RE: Daly Unit No. 3
Leak-off Test

CHEVRON DALY UNIT #3 14B-12-10-28 WPM

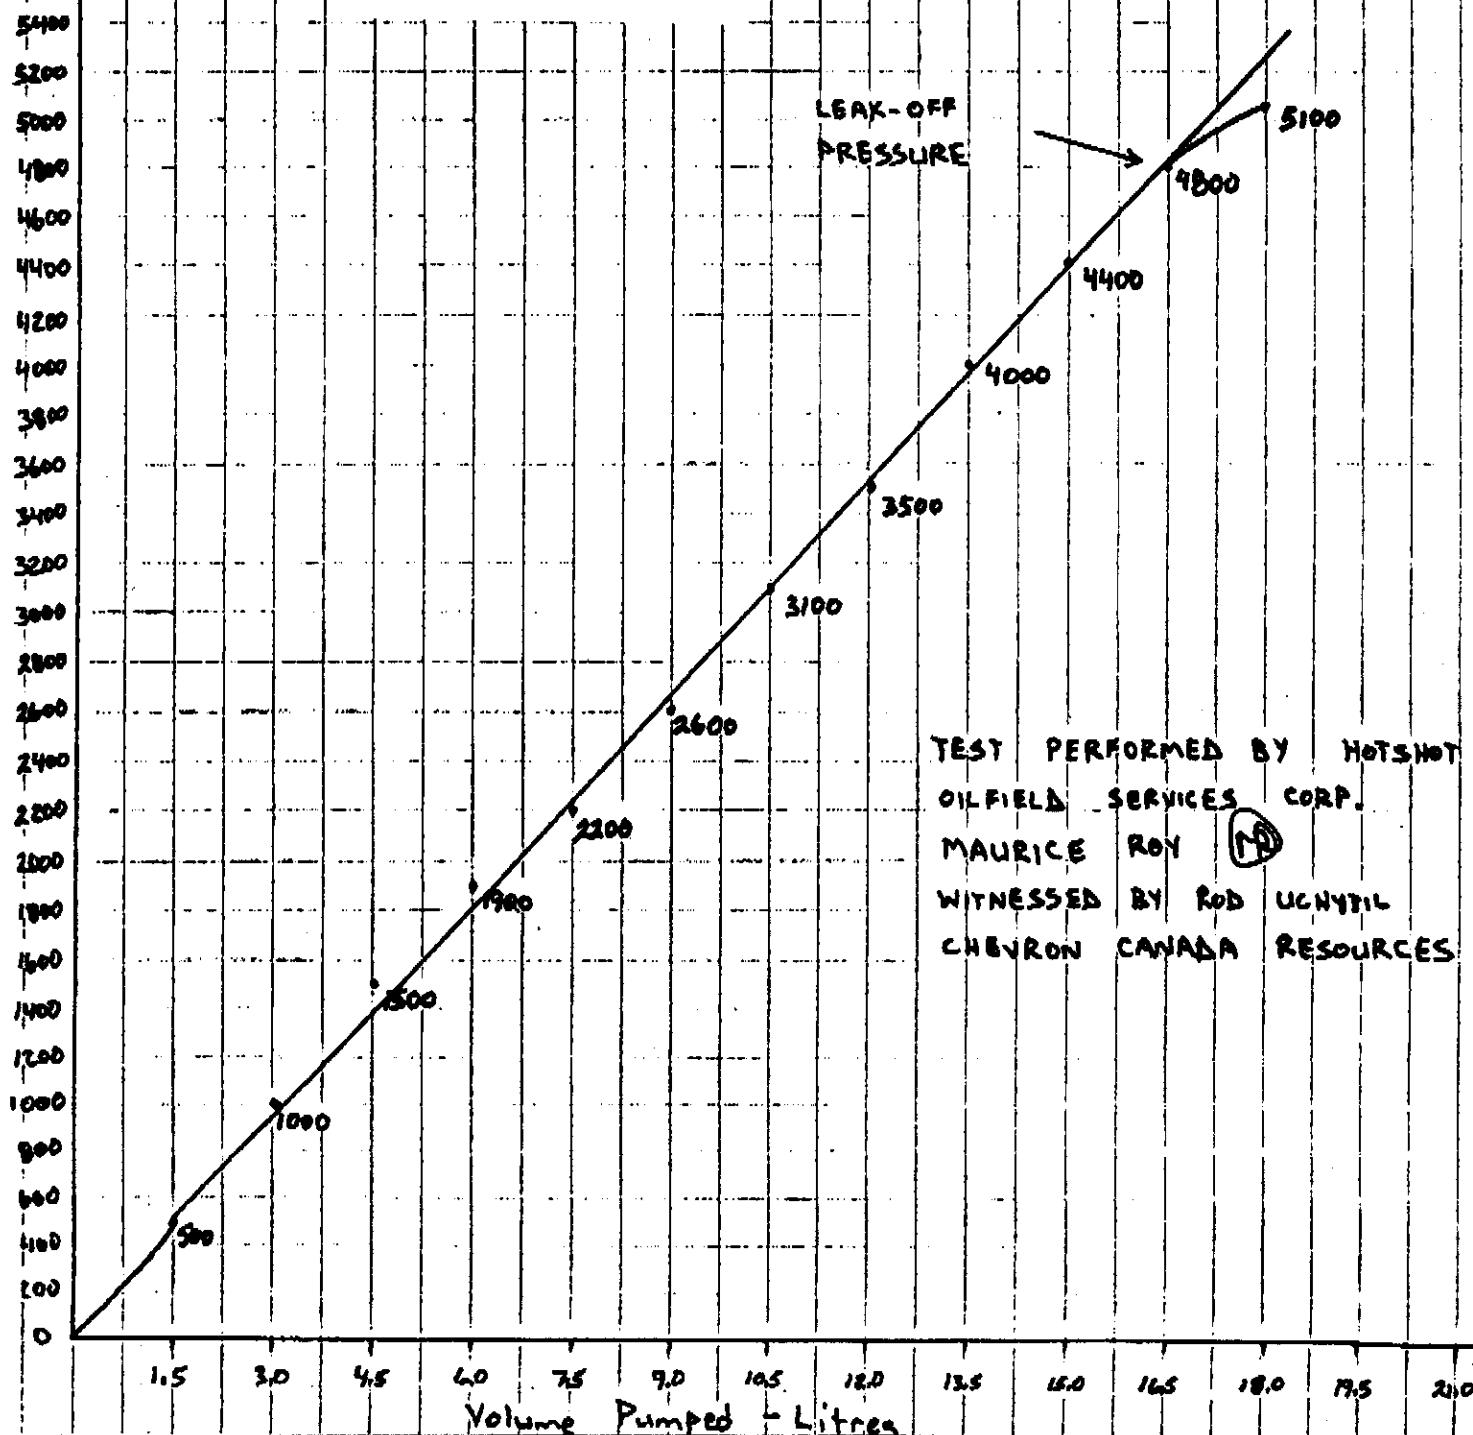
The Petroleum Branch has reviewed the results of the leak-off test conducted on the 14B-12-10-28 (WPM) well after drilling out the surface casing. The Branch is concerned that the high fracture gradient of 41.7 kPa/m is not representative. The leak-off test in Virden Roselea Unit No. 1 at 10B-30-10-25 (WPM) indicated a fracture gradient of 23.4 kPa/m. For this reason the Branch requests Chevron conduct a leak-off test below the surface casing on the next infill well drilled in Daly Unit No. 3 to assist in confirming the fracture gradient in the Daly Field.
